Project Name: Ginko Self Storage
 Description: Preliminary site plan and special land use approval
 Date on Agenda this packet pertains to: February 1, 2024

RE: Ginko Self Storage - Preliminary Site Plan Review- 4th Review

RE: Ginko Self-Storage
Preliminary Site Plan and Special Land Use – Review #4

The Fire Department has the following comments with regards to the 4th review of preliminary site plans for the project known as Ginko Self Storage.

PRELIMINARY LANDSCAPE PLAN

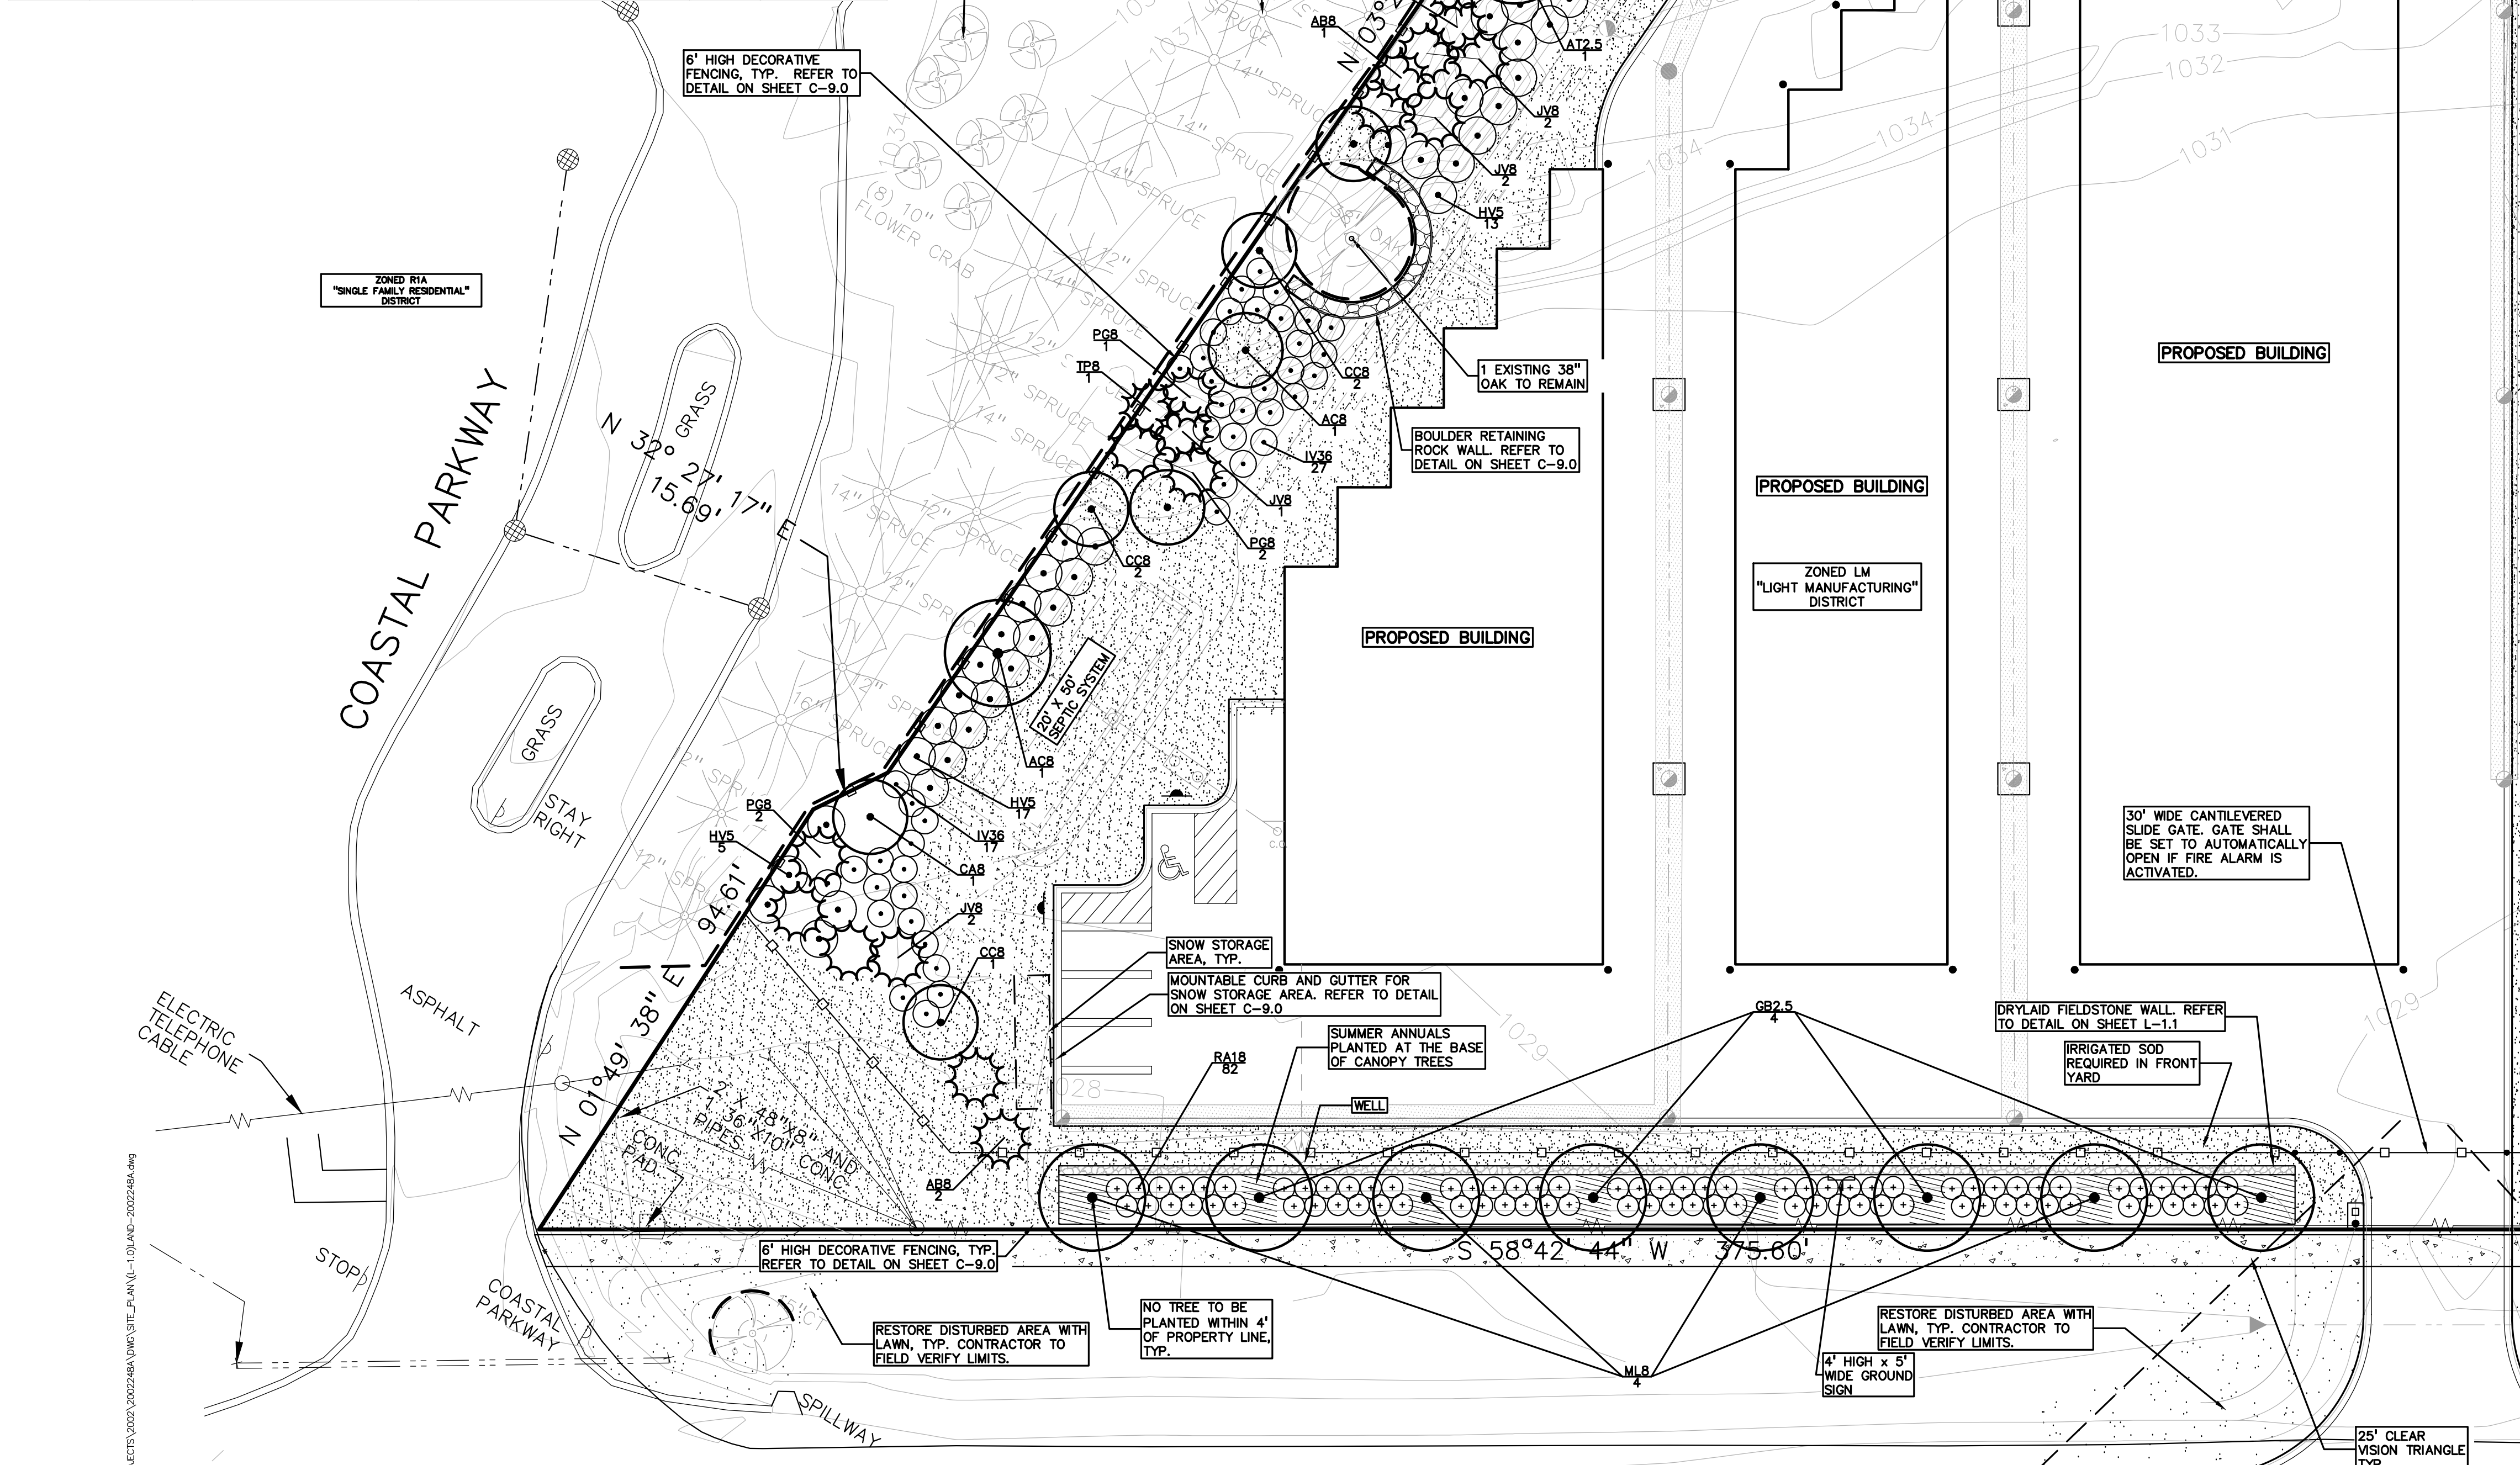
- **See comment on previous page regarding required greenbelt along west property line. (Comment addressed. A 38-foot setback from the west property line has been proposed).**

- **Calculations for required and provided interior landscaping shall be provided. (Comment addressed. The aforementioned calculations have been provided).**

- **The total number of evergreen trees in the Plant List is incorrect. Revise accordingly. (Comment addressed. The total number of evergreen trees has been corrected).**

- **The total number of trees in the Plant List is incorrect. Revise accordingly. (Comment addressed. The total number of trees has been corrected).**
- **233 shrubs are required for interior landscaping and 101 shrubs are proposed. Therefore, a variance is required from the Zoning Board of Appeals. (Comment rescinded. 233 shrubs have been proposed).**

- **47 trees are required for interior landscaping and 33 new trees are proposed. The landscape calculations indicate 48 trees are being counted as interior landscaping. Existing trees on the site being counted towards interior landscaping shall be identified on the plan. Off-site trees shall not be counted as interior landscaping for the proposed self-storage facility. (Comment outstanding. Greenbelt landscaping adjacent to the road right-of-way is being counted as interior landscaping. Therefore, the proposed amount of interior landscaping is deficient and requires a variance from the Zoning Board of Appeals. An extensive land form buffer (six-foot berm landscaped in accordance with the ordinance) is required adjacent to the road right-of-way, but not proposed; therefore, a variance is required from the Zoning Board of Appeals). (The Applicant's engineer stated a variance will be requested).**

- **The common name and scientific name are swapped for some species in the Plant List. Revise accordingly. (Comment addressed. The Plant List columns have been revised).**

- **An extensive land form buffer (six-foot berm landscaped in accordance with the ordinance), or, a land form buffer (three-foot berm landscaped in accordance with the ordinance) AND a six-foot masonry screen wall (landscaped in accordance with the ordinance) are required along the west property line. If not provided, a variance is required from the Zoning Board of Appeals. (Comment outstanding. A variance is required from the Zoning Board of Appeals). (The Applicant's engineer stated a variance will be requested).**

- All required landscape areas in excess of 200 square feet shall be irrigated to assist in maintaining a healthy condition for all plantings and lawn areas. **An irrigation plan shall be provided at final site plan.** (Comment remains as a notation). (A note has been added to Sheet L-1.0 noting the an irrigation plan is required at final site plan).

- **No more than two planted trees in a row shall be of the same species.** (Comment outstanding. Three Eastern Red Cedar trees are planted in a row along the west property line). (Comment outstanding. Three white spruces in a row are now proposed along the west property line). (Comment addressed. The landscape plan has been revised accordingly).

- **Pine trees are prohibited in the Township. Replace White Pine with a different evergreen species.** (Comment addressed. Pine trees are no longer proposed).

- **The planting detail mentions mulch, and the ordinance states the mulch product itself shall be at least doubled-shredded quality. Revise accordingly.** (Comment addressed. Double-shredded mulch has been specified on the landscape plan and details).

- **Lawn in the front yard shall be sod and lawn elsewhere shall be hydroseed or sod.** (Comment addressed. It appears irrigated sod lawn has been proposed around the entire site except in the landscaped area along the west property line. In the Key on Sheet L-1.0 there is a symbol for restored lawn, though staff did not locate any such areas on the plan. If not proposed, this item shall be removed from the Key). (The Key has been modified to indicate restored seed lawn at areas disturbed in the right-of-way or adjacent properties).

DRAWING TITLE
PRELIMINARY FLOOR PLAN AND BUILDING ELEVATIONS

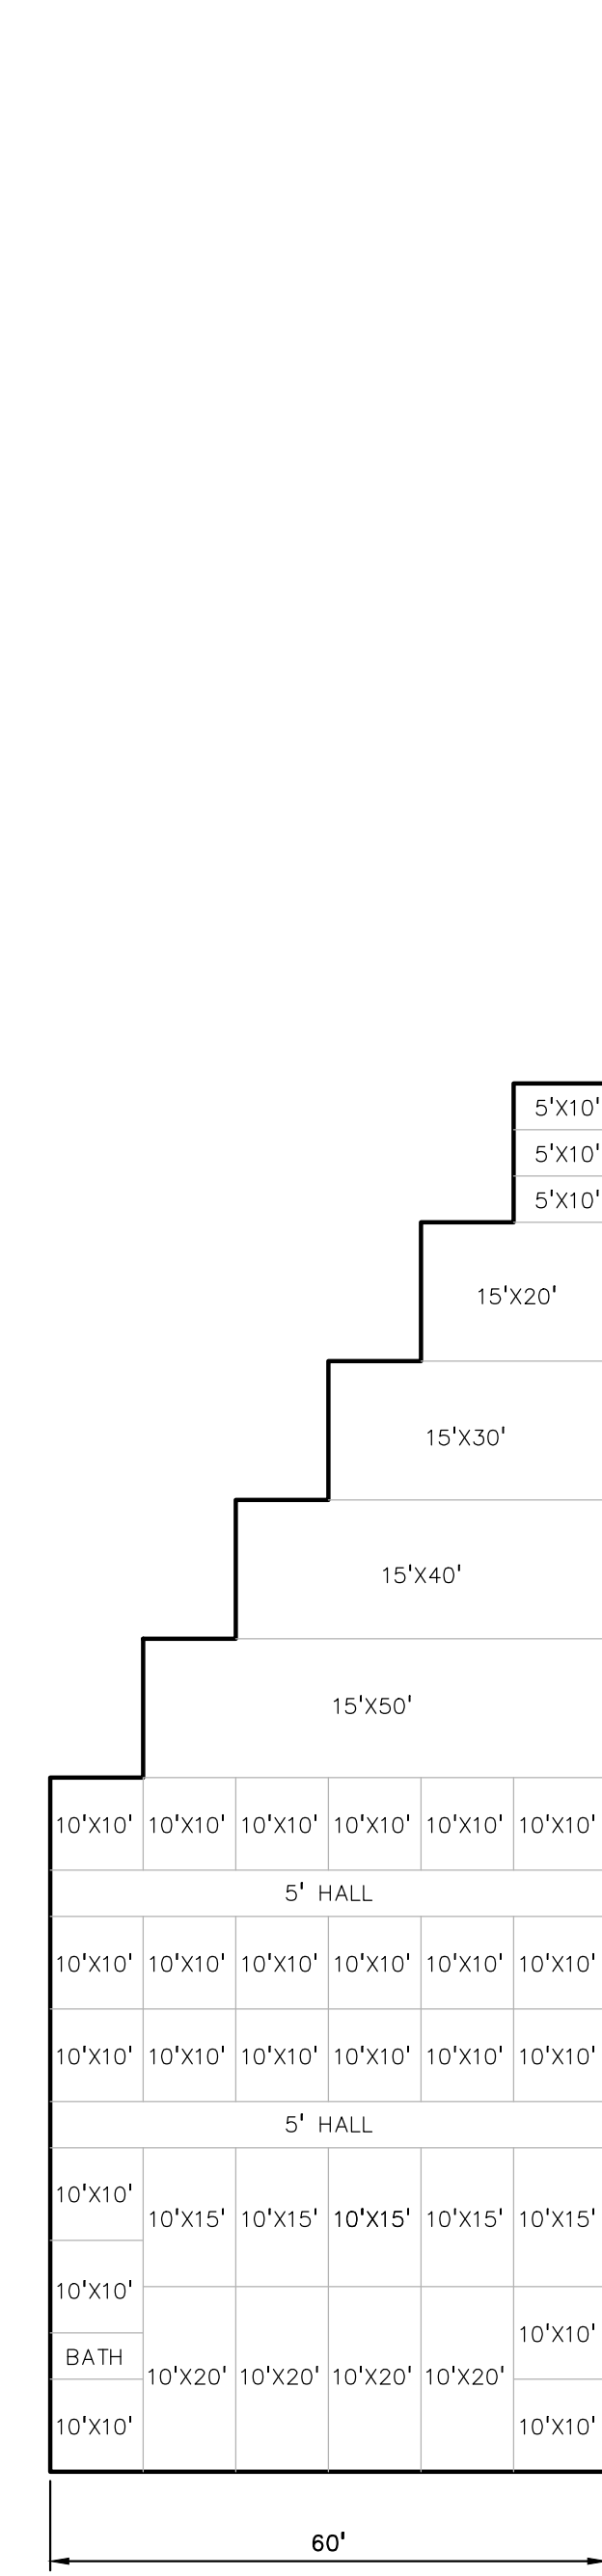
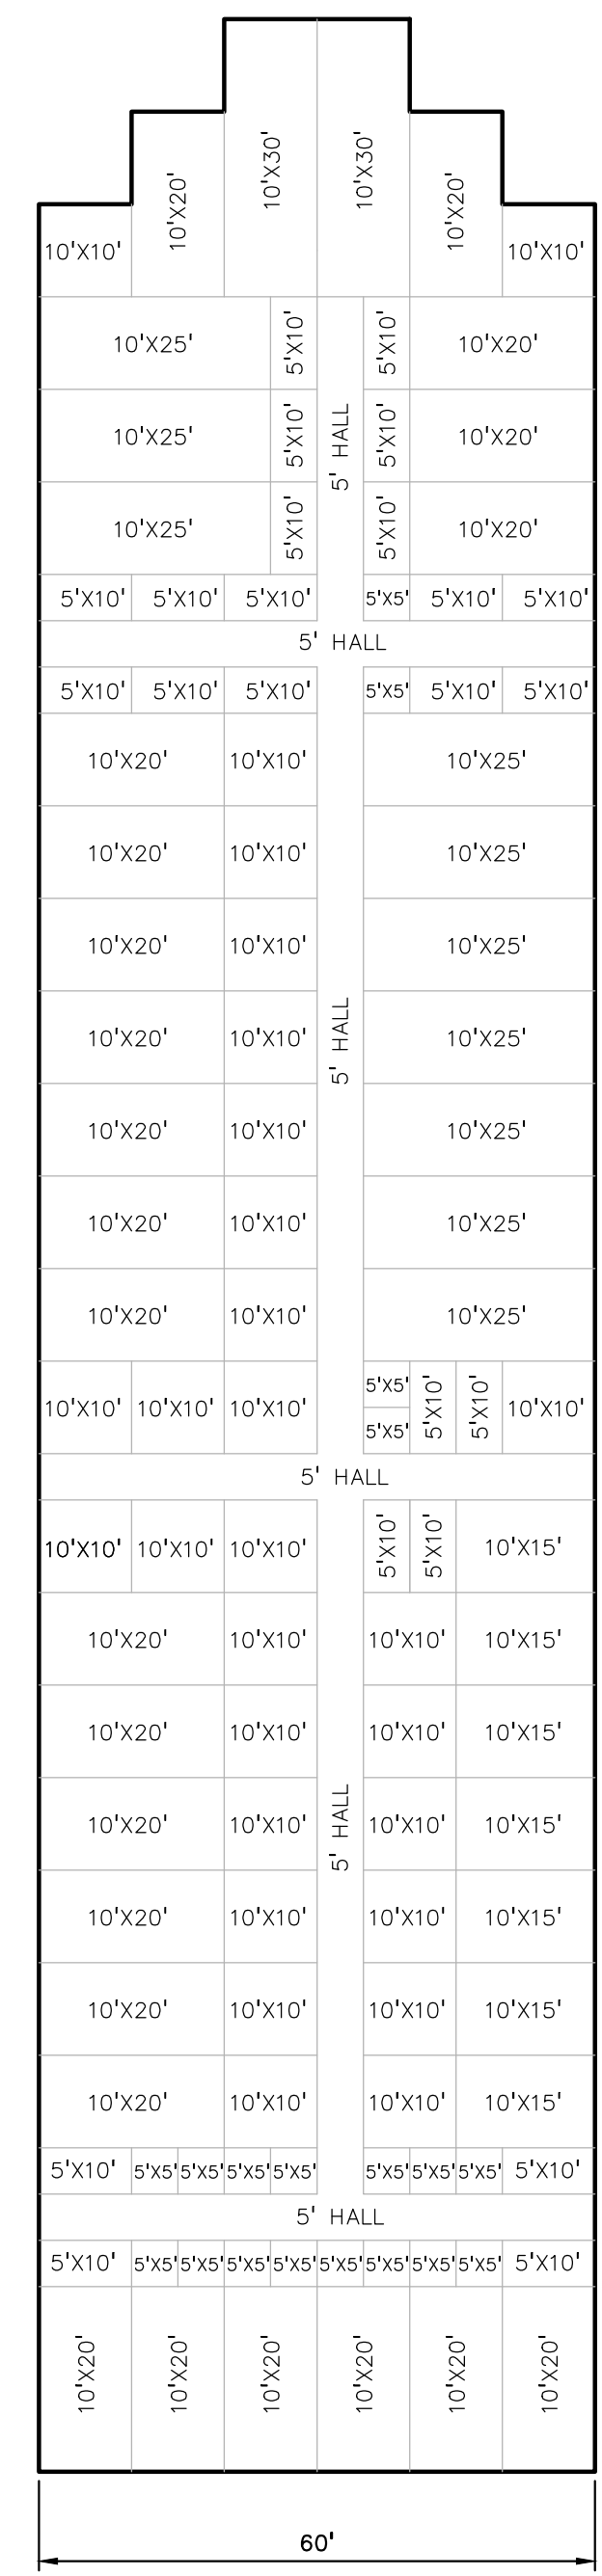
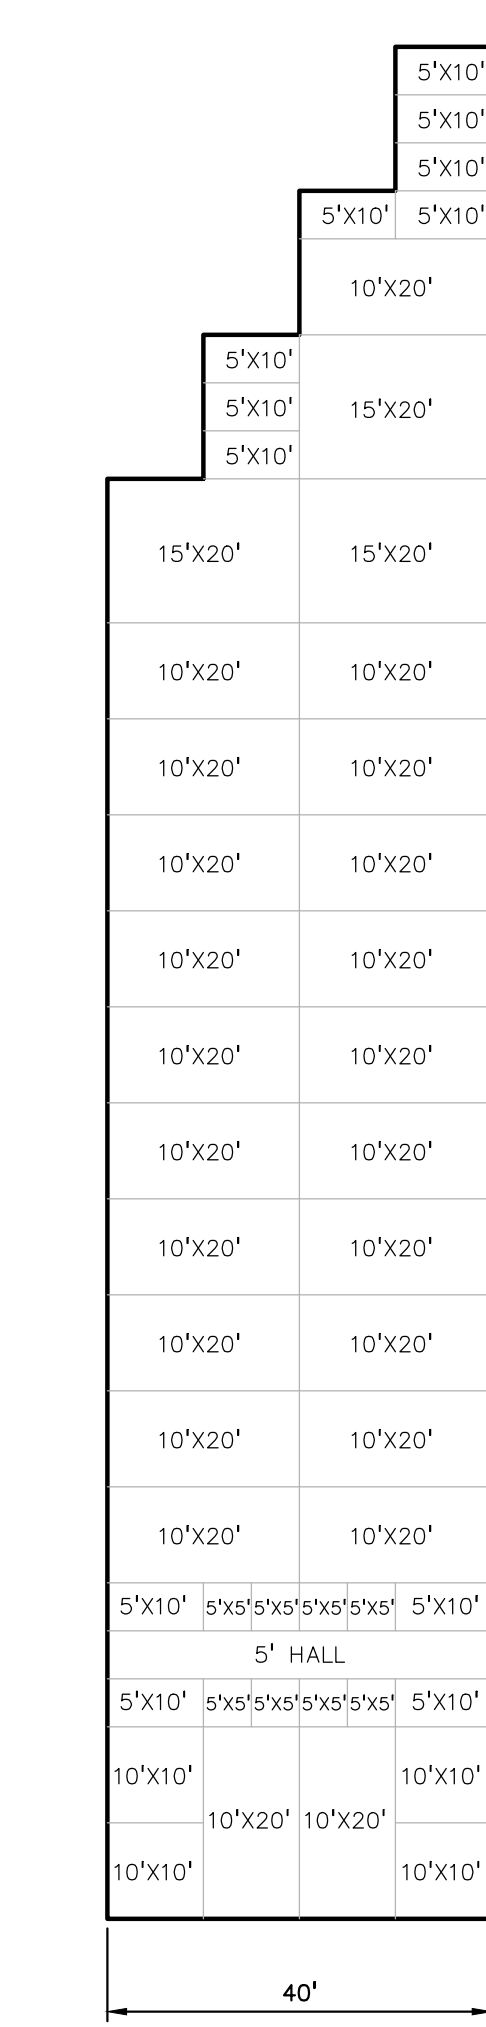
The Applicant is proposing to construct 210 (**now 203**) storage units among three single-story buildings totaling 20,950 (**now 28,950**) square feet in size. **The building footprint area listed in the Site Data Table and floor area listed on the site plan review application are incorrect – revise accordingly.** (**Comment addressed. The building sizes have been updated.**)

- Building 1: 3,750 (**now 6,750**) square feet (contains a bathroom)
- Building 2: 6,900 square feet
- Building 3: 10,300 (**now 15,300**) square feet

A sample board of building materials to be displayed at the Planning Commission meeting and elevations in color are required by the zoning ordinance and must be submitted at final site plan. Additionally, the address (street number) location shall be shown on the building. Six-inch-tall numbers visible from the street shall be required. The address locations are subject to approval of the Fire Marshal. (Comments remain as a notation).
(Street number locations on the buildings are shown on Sheet A-1.0).
